16_38 Re-Symbolize Existing Levels for Paved Shoulders

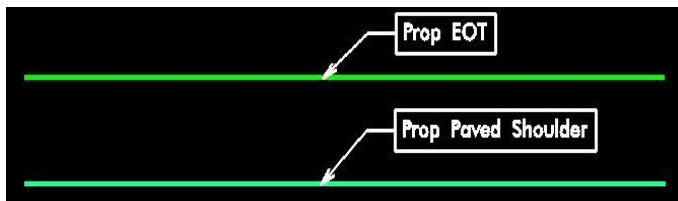
1. FOR VIEWING ON CADD SCREEN ONLY, CHANGE COLOR OF PROPOSED PAVED SHOULDERS
"Can the color for the proposed edge of travelway (EOT) or the proposed paved shoulder levels be changed to distinguish the difference between the two? Right now they are both same green."
2. FOR PLOTTING ONLY, CHANGE SHADE INTENSITY OF SIDEWALKS
"Can the shade intensity for the proposed sidewalks (EOT) or proposed concrete islands be changed to distinguish the difference between the two? Right now they are both lightly shaded."

(2) For plotting purposes only, the proposed concrete sidewalk shapes will be shaded darker than the concrete island shapes. It is desired that this shade intensity change be "**conservative**" by design. Note that this change **will not** effect existing sidewalks already placed in Microstation file models. This change only effects what's being plotted. Thus be aware that for plan sheets with sidewalks, the new sheet being plotted will not have the same shade intensity as the old ones. See picture below. Also note the modification to the PSH Legend Sidewalk cell.
